Comments and Responses Volume 6

San Francisco Public Utilities Commission CALAVERAS DAM REPLACEMENT PROJECT

San Francisco Planning Department File No. 2005.0161E
State Clearinghouse No. 2005102102

Figure 1. Demonstration of hydrologic variability at the USGS gage 11179000 (Niles Canyon)

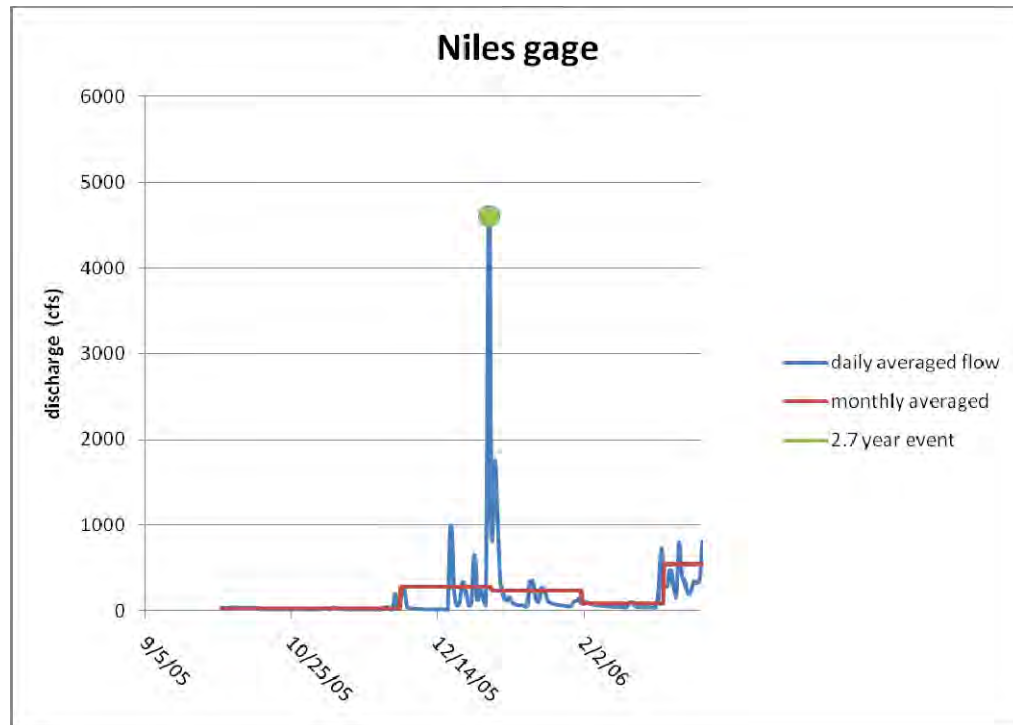
of the month. However, with the use of average monthly flows in the HH/LSM, the impacts of significantly reducing flows during a portion of the month would be obscured, or entirely overlooked in the DEIR impact analysis. Figure 1 demonstrates the typical annual variability that may be encountered in any given year, along with monthly averaged flow rates used for the HH/LSM analysis.

Instead, the DEIR analyses of downstream flow impacts should be conducted utilizing a hydrologic model with a daily time-step developed for the Alameda Creek Watershed. Given the highly variable flow conditions in the watershed, a daily time step is necessary to analyze and properly assess impacts to both fisheries and water supply. As an example, ACWD uses a daily operational model, with over 70 years of daily hydrology on Alameda Creek. This ACWD model is used for the operational planning of ACWD water supply facilities in the Alameda Creek Flood Control Channel. In order to facilitate the implementation of a similar daily hydrologic model of the SFPUC's Alameda Creek watershed operations, in August 2009, ACWD and SFPUC entered into a letter of understanding (LOU) to develop a hydrologic model of the watershed which simulates flow downstream of Calaveras Dam and Alameda Creek Diversion Dam on a daily basis. This hydrologic model has been recently completed, and the results reviewed with both the California Department of Fish and Game (DFG) and NOAA Fisheries. Prior to finalizing the DEIR, the downstream hydrologic impacts of the CDRP should be re-evaluated with this daily model to adequately address the highly variable flow conditions in the watershed. As described in the comments below, the

Figure 3 USGS Gage data for April-May 2008 Calaveras Dam low flow releases

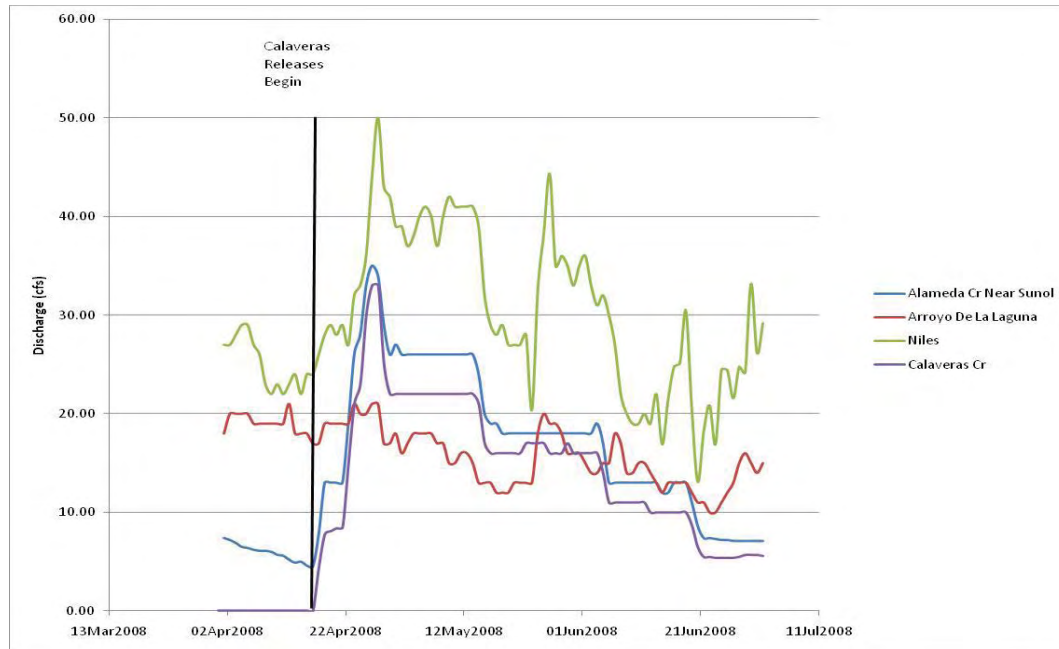
habitat directly downstream of the CDRP. A Calaveras Dam flow release performed by SFPUC in late spring/early summer of 2008, USGS data from stations 11173500, 11173575, and 1117900, shown on the map in Figure 2, indicate that flows originating at the outlet of Calaveras Reservoir clearly have the potential to travel through the Sunol Valley and are able to be conveyed to the Niles Canyon gage and through the Alameda Creek Flood Control Channel. This data is presented below in Figure 3. As shown in Figure 3, the controlled releases from Calaveras Reservoir ranged from approximately 5 cfs to 30 cfs over a period of several days. Once the Calaveras releases began on April 17, 2008, an increase in downstream flows at the Niles gage (located directly upstream of the Flood Control Channel) was observed. The flows at the Niles gage continued to track relatively closely with the Calaveras releases (with some losses between the Calaveras and Niles gages). This controlled release from Calaveras Reservoir has clearly demonstrated that releases and/or bypasses from SFPUC's diversion facilities in the upper watershed travel down to the lower reaches where adequate flows will be needed for steelhead migration to access the habitat below the CDRP. As a result, the DEIR should account for the direct hydrologic connection between the CDRP and the downstream reaches, and address how flows that are diverted to the Calaveras Reservoir affect steelhead migration, as discussed in more detail below.

- D. The DEIR should address the need for sufficient flow releases to provide for migration of steelhead into and out of Sunol Valley (and the spawning/rearing habitat directly downstream of the CDRP), and through Niles Canyon downstream to San Francisco Bay. As described in the comments above, significant progress is being made on providing steelhead passage through the Alameda Creek Flood Control Channel, with plans in place to provide complete fish passage through this lower reach in the next several years. In addition, data from the USGS gaging stations clearly demonstrate that: 1) the CDRP will have a significant impact on downstream flows, and 2) these flows would otherwise have had the potential to travel downstream through the Sunol Valley, Niles Canyon and the Flood Control Channel and ultimately to the Bay.

Figure 4. Water year 2001 hydrograph, and needed discharge for adult fish passage

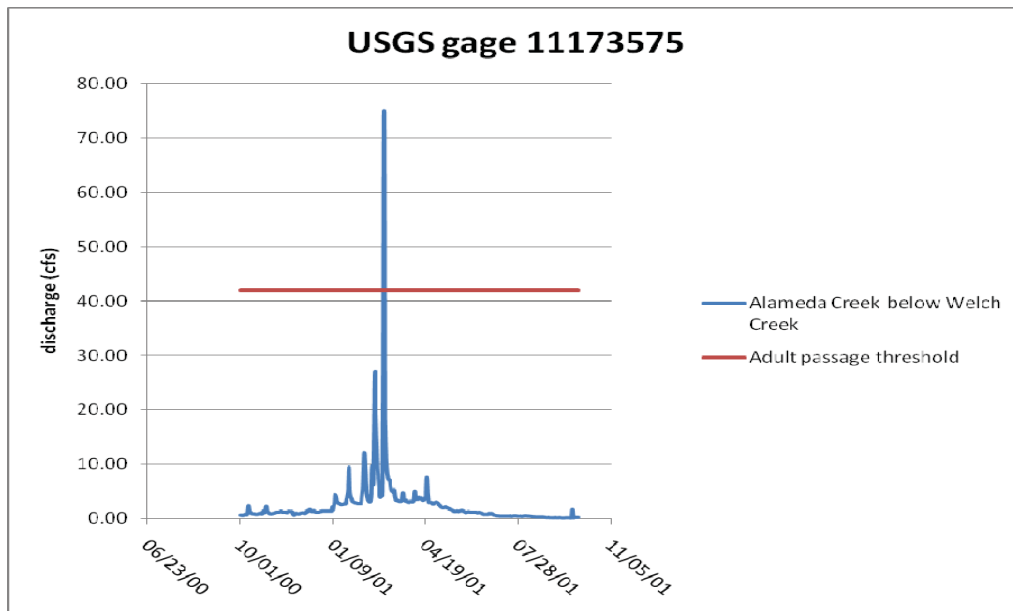
Rather than providing the needed flows for steelhead migration, the DEIR states that there will be sufficient opportunities for in-migration during high flow events, without providing additional releases to support the steelhead in-migration. However, as shown in Figure 4 below, an analyses of flow data at the USGS gaging station on Alameda Creek at Welch Creek, indicates that under pre-DSOD restrictions (Water Years 1999-2001) on average, adequate flows for steelhead in-migration occurred approximately 17% of the time during the in-migration season of December through March. In WY 2000 adequate flows were provided only 0.8% of the time, and WY 2001 provided adequate flows 32% of the time. Given that the DEIR acknowledges that the flow conditions under the CDRP would be similar to those which occurred under pre-DSOD conditions, it is clear that the DEIR fails to provide adequate commitments for the flows needed for steelhead in-migration. Similarly, adequate flows from the rearing habitat in the upper watershed downstream through Sunol Valley, Niles Canyon and Flood Control Channel must be provided such that smolts can out-migrate from the rearing habitat in the upper watershed to San Francisco Bay.

FIGURE 2: CALAVERAS DAM VICINITY

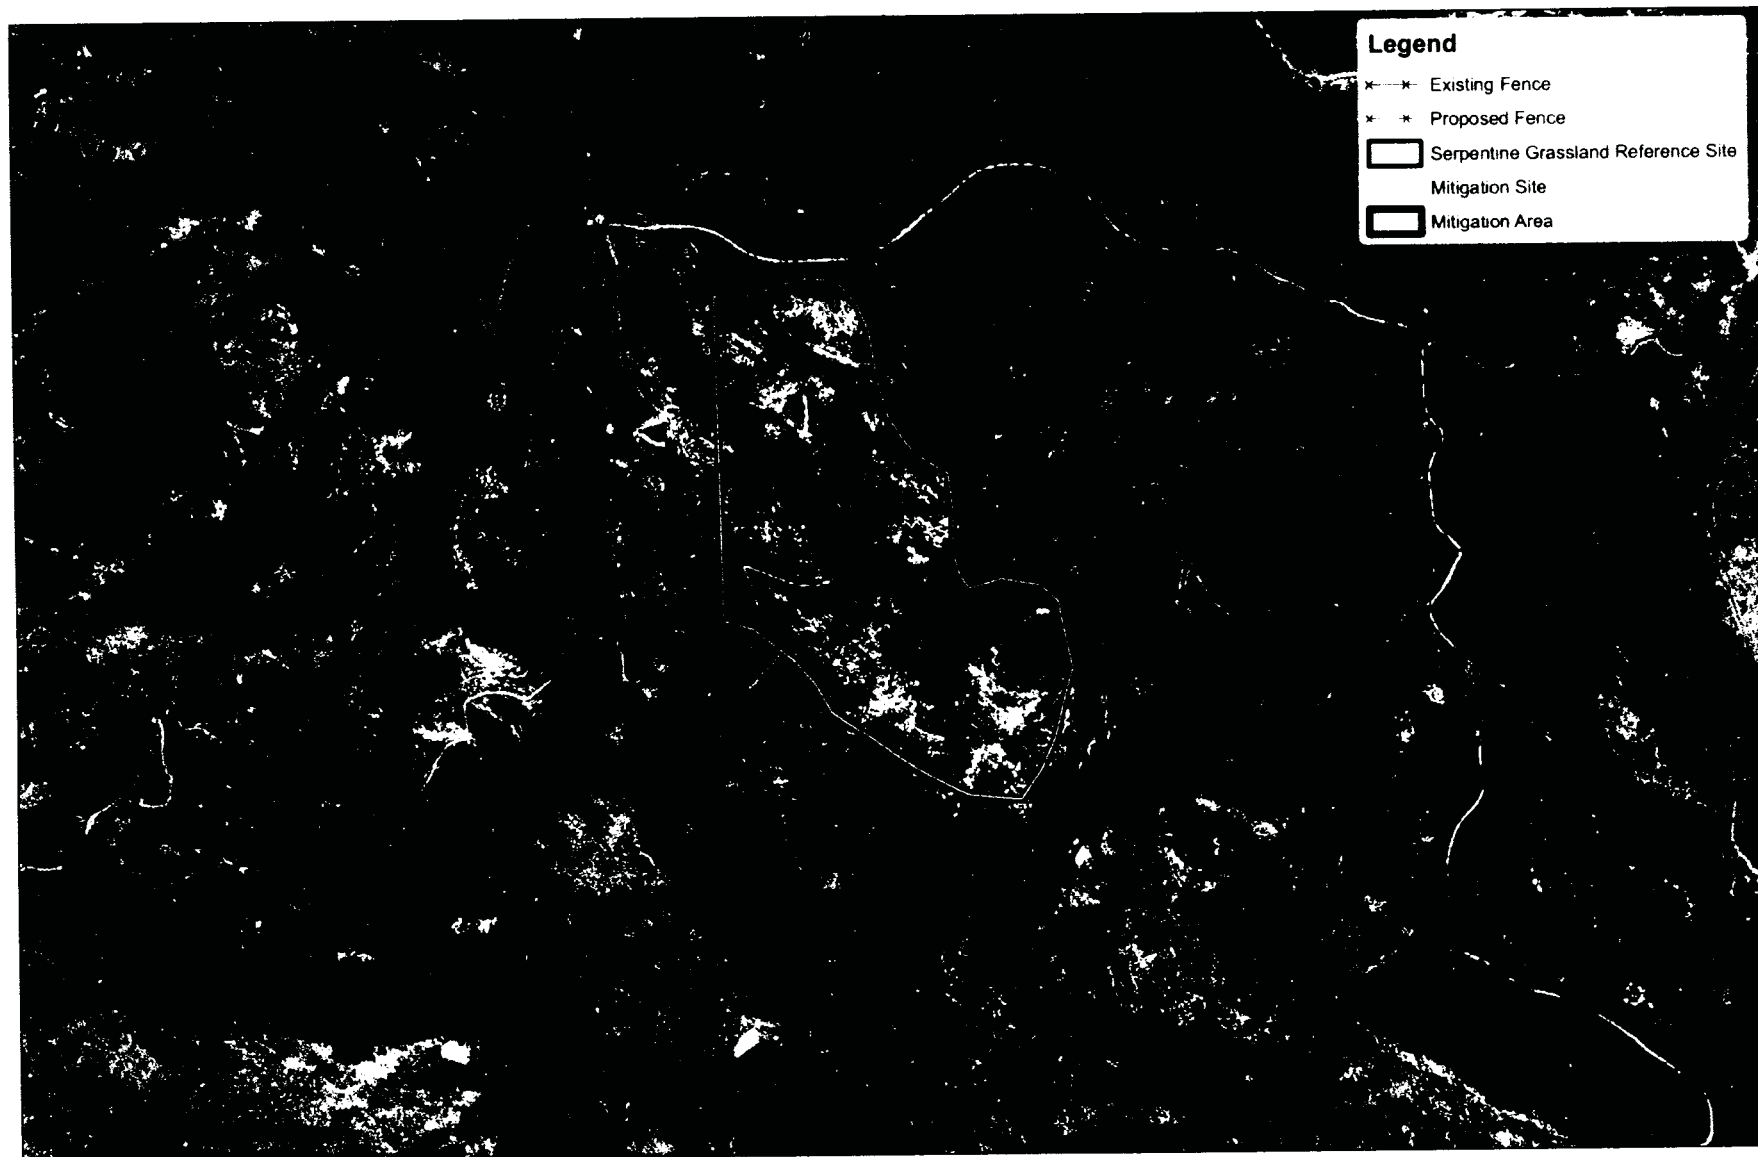
We received an October 21, 2009, Public Notice (#29979S) from the US Army Corps of Engineers regarding the subject Project. The notice appears to contain the missing Figure 2 from Appendix C-2 of the DEIR. Figure 2 shows only the general location for the mitigation area. Through a separate request we obtained a "Figure 3-6 Goat Rock Mitigation Area" from Robert Smith at the US Army Corps of Engineers. This figure provides considerably more detail on Goat Rock; however, this figure was not contained in the DEIR, Appendix C-2 or in the referenced Corps Public Notice. See *attached Figures 2 and 3-6*.

FIGURE 3-6: GOAT ROCK MITIGATION AREA

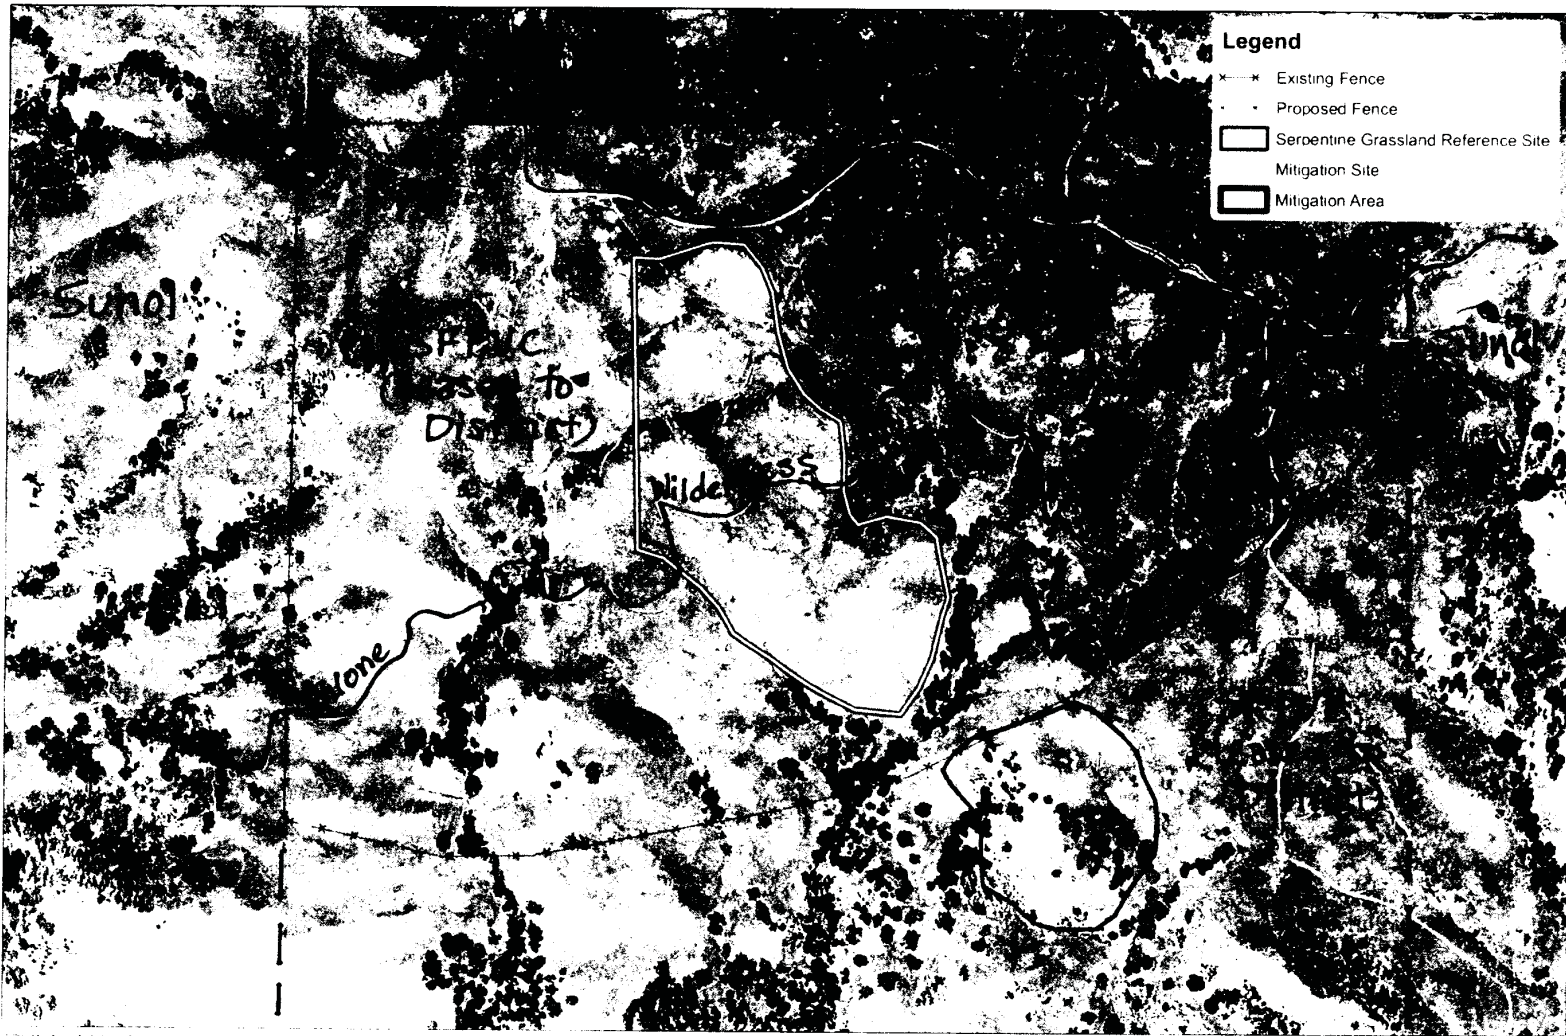
The proposed Goat Rock mitigation area depicted on Figure 3-6 is considerably larger than the 35-acres stated in the DEIR. The proposed fenced area, including the mitigation site and serpentine grassland reference area are about 200 to 250 acres in size. The mitigation area contains a 1.94 mile segment of the Ohlone Wilderness Trail and a 0.70 mile segment of the Homestead Trail. See *the attached annotated Figure 3-6 for more information*.

Figure 3-6 shows that proposed new fencing would create barriers to the use of the two park trails. Gates have not been identified on the figure that would allow for their continued use. The DEIR has no discussion about how this area might be affected by management changes and/or restrictions resulting from its use as parkland. This significant effect was not identified in the DEIR. These potential effects should also be identified on page 5-14 of the DEIR.

FIGURE 4.4.2: REGIONAL LAND COVER

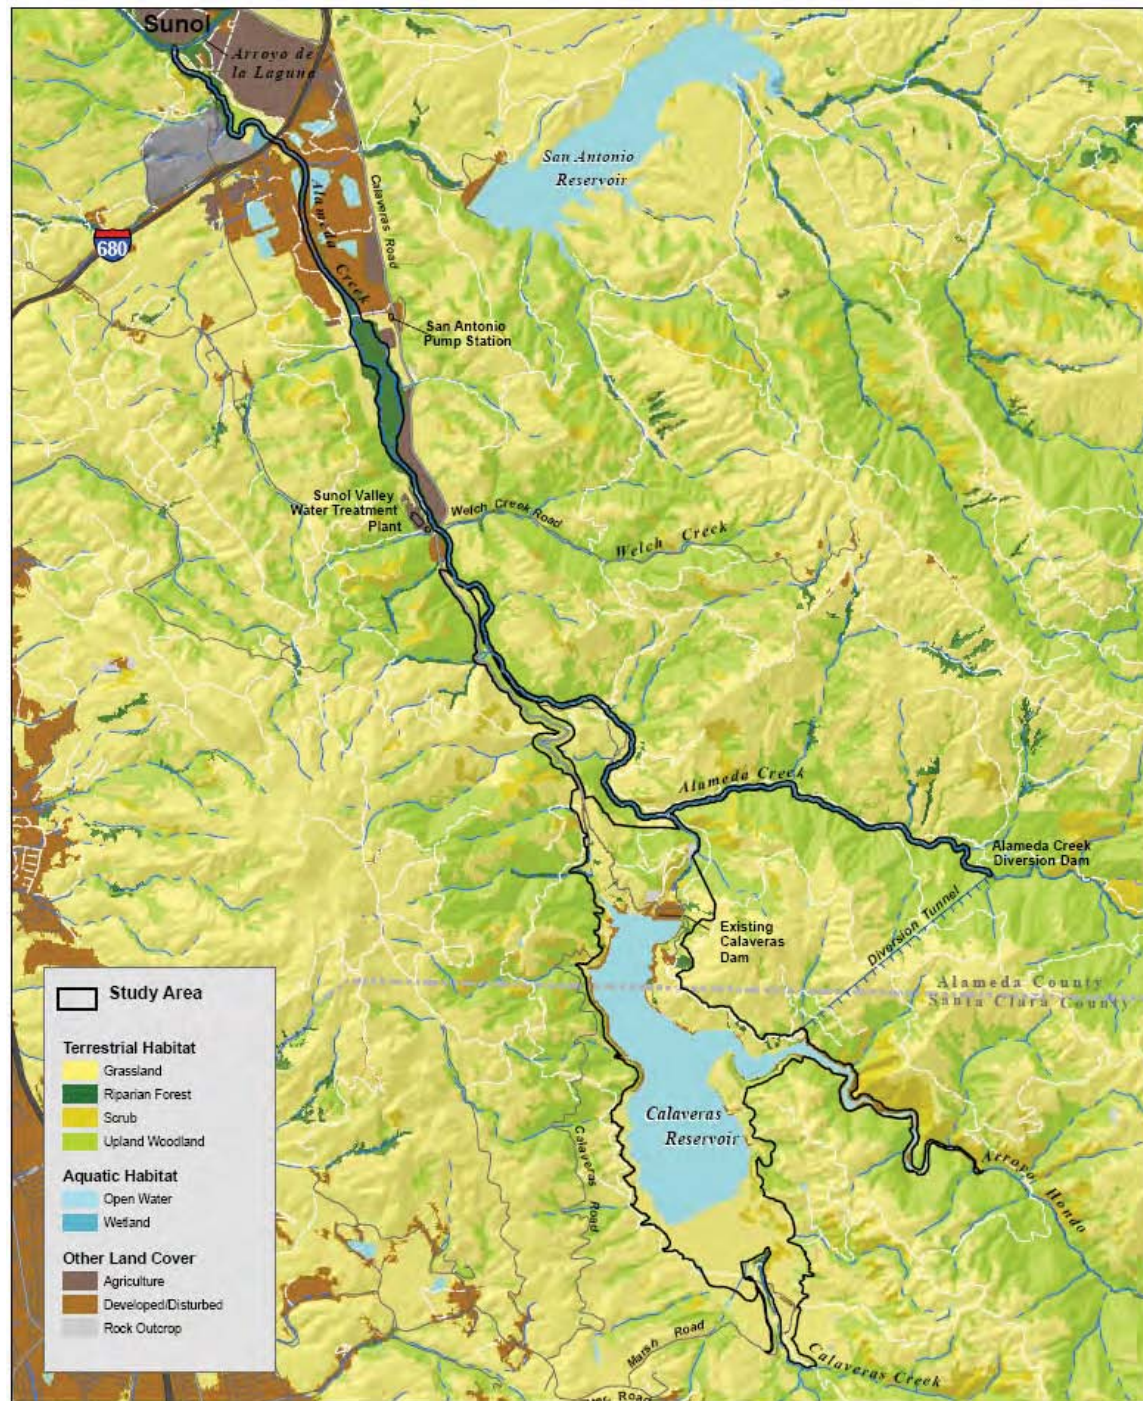
Figure 4.4.2 (Regional Land Cover) illustrates that this project may impact nearly all (~95%) of the Riparian Forest habitat downstream of the Sunol Valley Water Treatment Plant. CNPS believes this could be construed as equivalent to destroying the entire stream and its habitat. Yet, this impact was not clearly called out. CNPS believes partial impacts to streams may be possible to mitigate on site in a reasonable manner, but we are not convinced that the impacts from inundation of this area are being taken seriously by the SFPUC. CNPS requests that the project and its impact areas be overlaid onto Figure 4.4.2 in order to provide a new figure to show impact location with relation to the entire study area.
